From: Detterman, Mark, Env. Health
Sent: Thursday, February 07, 2013 9:53 AM
To: 'Paul Parmentier'
Cc: Peter Serrurier; Dave Murray; maz@bctlawcom.thesourcegroup.net; Matt Sutton; Paisha Jorgensen
Subject: RE: Paco Pump: R00320: deliverable due Feb 8 2013

REVISED PROPOSED MONITORING WELL AND SUB-SLAB VAPOR POINT LOCATIONS (JANUARY 2013)

9201 SAN LEANDRO STREET
OAKLAND, CALIFORNIA

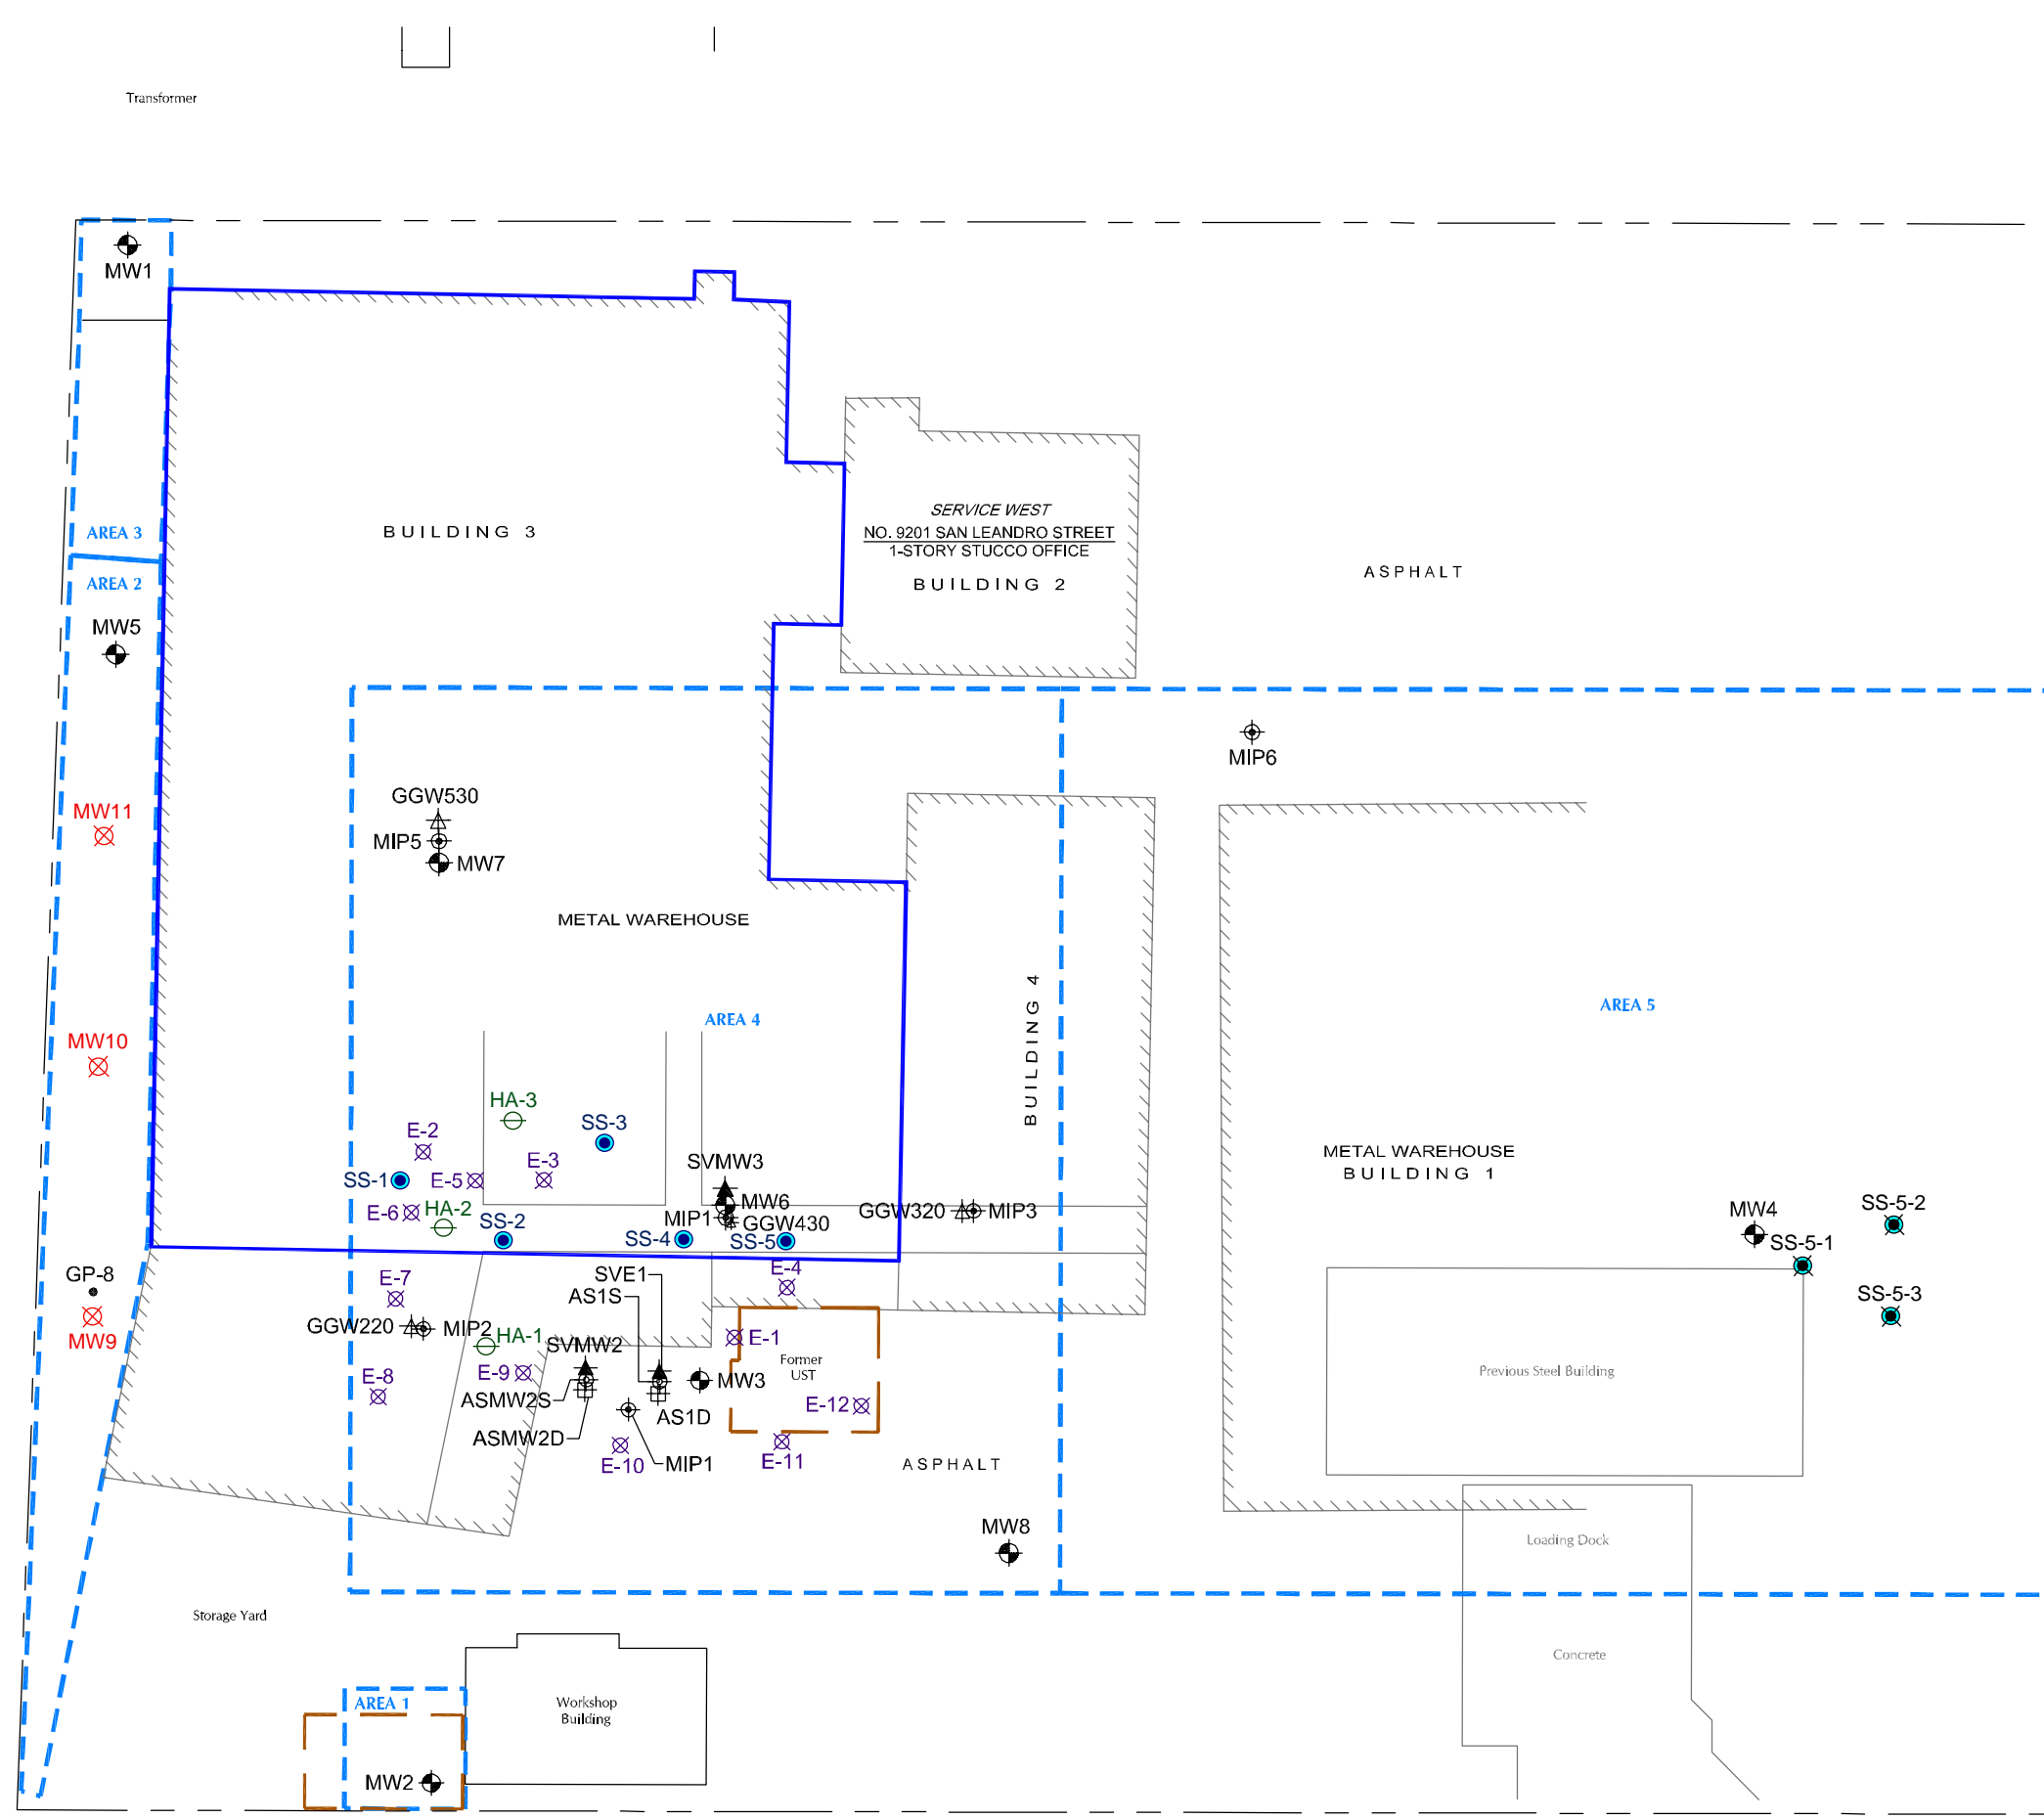
I have attached the revised figure showing final locations for the sub-slab vapor points, soil borings, and new monitoring wells. This figure incorporates your most recent suggestion of placing a sub-slab vapor point inside the building near E-4. Our RI Work Plan now consists of eight sub slab vapor points (five in Area 4 and three in Area 5), three hand augured soil borings, and three new monitoring wells. All technical comments provided by you in your November 16, 2012 *Modified Work Plan Approval* will be incorporated into the remedial investigation field work.

I have attached the revised figure showing final locations for the sub-slab vapor points, soil borings, and new monitoring wells. This figure incorporates your most recent suggestion of placing a sub-slab vapor point inside the building near E-4. Our RI Work Plan now consists of eight sub slab vapor points (five in Area 4 and three in Area 5), three hand augured soil borings, and three new monitoring wells. All technical comments provided by you in your November 16, 2012 *Modified Work Plan Approval* will be incorporated into the remedial investigation field work.

Paul,
While this has taken awhile, I'm hopeful that the site will move along more quickly than otherwise as we attempt to wrap in more of the identified data gaps or areas of concern. The addition of the subslab point SS-5 looks good. Please proceed as you have proposed; it is appropriate to generate the data and incorporate it into a SCM / CSM thereafter. While I didn't put a lot of emphasis on it (TC 4 in the November 2012 letter), please do additionally focus on collection of shallow soil samples (in addition to those needed for standard well / bore installation at indications of contamination, lithology changes, or just above gw). The LTCP review can really depend on that data, and the site will progress quicker if that data gap is attended to at this time rather than requiring another mobilization.
Good luck with the field work.
